Newtown Railway Works, Ashford, Kent

Planning Application Reference PA/2026/0171 and PA/2026/0229

**Desktop Assessment and Supporting Submission
for South Willesborough & Newtown Community Council**

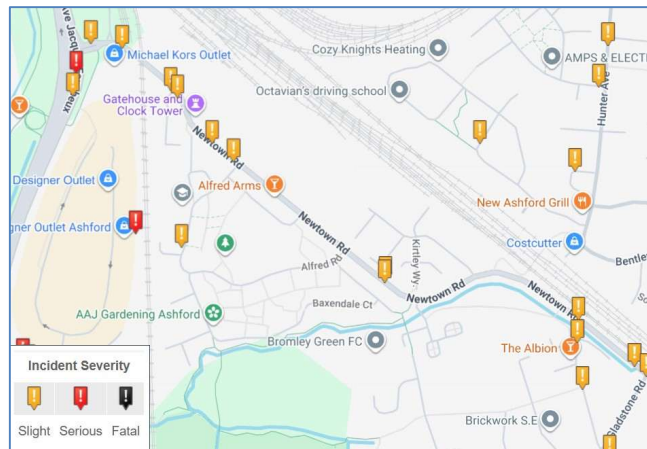
Conversely to the above-mentioned number of cycling spaces at the Railway Station (around 450 vs the application site's 1000), there are around 2400 car parking spaces vs the application site's 563. This is a huge disparity and suggests that either Network Rail have it wrong, or the Developer does.

Collisions on Newtown Road. Source: CrashMap

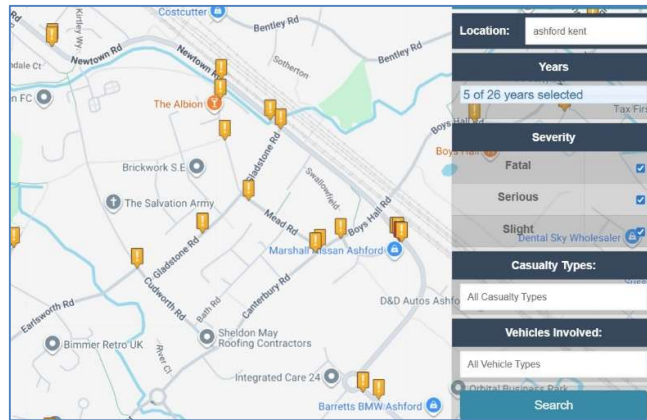
Data for the most recent five-year period (the accepted period in the Highways profession) 2020-2024 inclusive, shows 21 collision injuries along Newtown Road, comprising 20 slight and 1 serious injury. This is reasonably high for an unclassified 'local' distributor road. It should be noted that although there is little published data on unreported collisions the Department for Transport (DfT) suggests that 'for every reported and recorded injury collision there could be as many as 5 unreported injury collisions and 20 damage-only collisions'. Near misses could be as many as 300 per recorded injury collision.
